Norfolk Vanguard Offshore Wind Farm Applicant's Response to Request for Information

Appendix 2 Environmental assessment for
trenchless crossing of B1149

Document Reference: ExA;WQ;11.D10.1.App2

Date: 28 February 2020

Figure 1: Norfolk Vanguard Cable route crossing the B1149

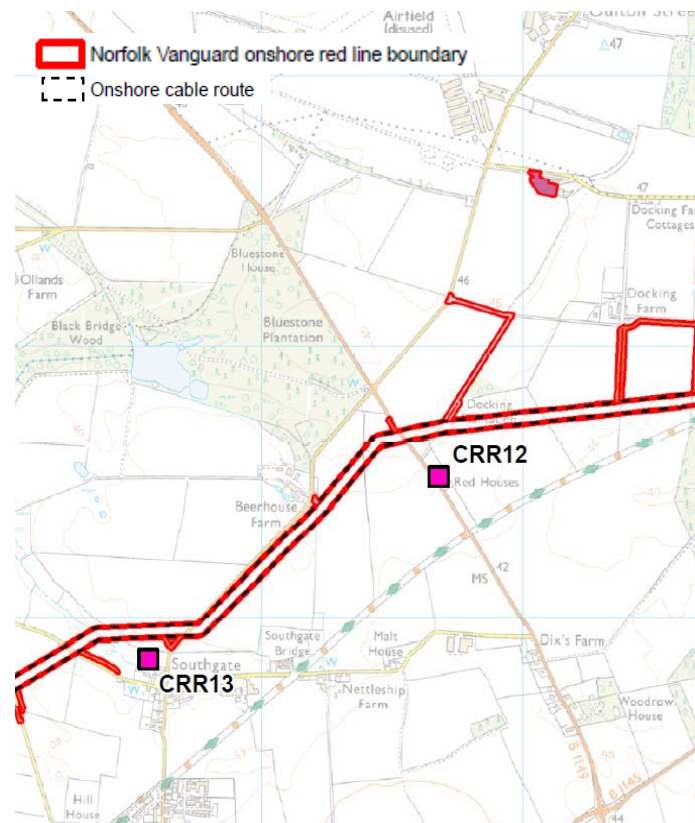
2. The construction methodology assessed for the B1149 crossing within the application submitted in June 2018 was for an open cut trench solution. The point at which the onshore cable route crosses the B1149 is shown on Figure 1 below. The nearest residential property (CRR12) is located approximately 165m south of the crossing point and is also identified on Figure 1.

Figure 3: Proposed trenchless crossing at the B1149, if required

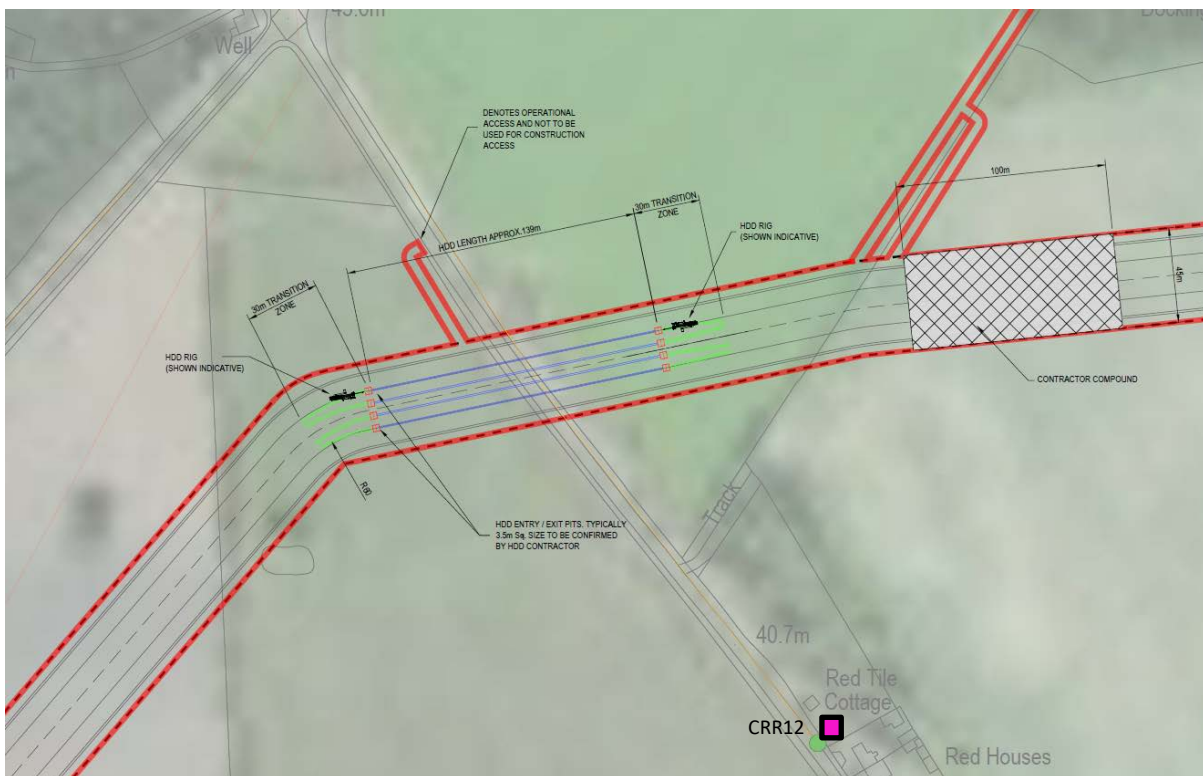
- Where the cable corridor crosses the B1149, as shown on Figure 1, no works compounds or mobilisation areas have been included within the current Order limits as submitted for the DCO application. In line with a request from Norfolk County Council, in order to accommodate a potential trenchless crossing in this location, a bespoke design has been developed whereby a single compound can be included within the existing Order limits. This compound would be set back approximately 250m from the crossing location, rather than alongside the trenchless crossing launch and exit locations. This arrangement ensures that the required trenchless crossing compound area could remain wholly within the Order limits. This bespoke arrangement is shown on Figure 3.

- The bespoke design only accommodates the Horizontal Directional Drill (HDD) trenchless crossing method (and no other trenchless crossing method) to minimise supporting construction compound requirements, such that the compound can be contained wholly within the current Order limits. Other trenchless crossing methods such as auger boring, pipe jacking and micro tunnelling could not practicably be employed here because additional temporary land adjacent to the launch and reception pits would be needed to support the plant and materials required to sink shallow shafts at both the launch and reception pit. At all other trenchless crossing locations flexibility is retained for all trenchless crossing methods so that the most

7. The HDD method minimises the temporary construction compound requirements due to the surface to surface drilling method which avoids the need to sink shallow shafts at the launch and reception pit. The bespoke design therefore includes a single temporary construction compound in the vicinity of the launch pit to support the drilling activities. A temporary construction compound at the reception pit can be excluded with this method and works can be wholly contained within the Order limits.

8. However, there is still a requirement for a separate construction compound. In order to accommodate this construction compound within the current Order limits, this would be located approximately 250m from the trenchless crossing launch site; this will result in inefficient construction methods due to double handling of materials (delivery to compound for storage with subsequent 'shuttling' between the compound and the launch site) and similar impacts to workforce double movements between the compound (for parking) and the launch site. Furthermore, the exclusion of a temporary construction compound adjacent to the reception pit will result in the intricate management and movement of materials and plant within the Order limits whilst works are being conducted.
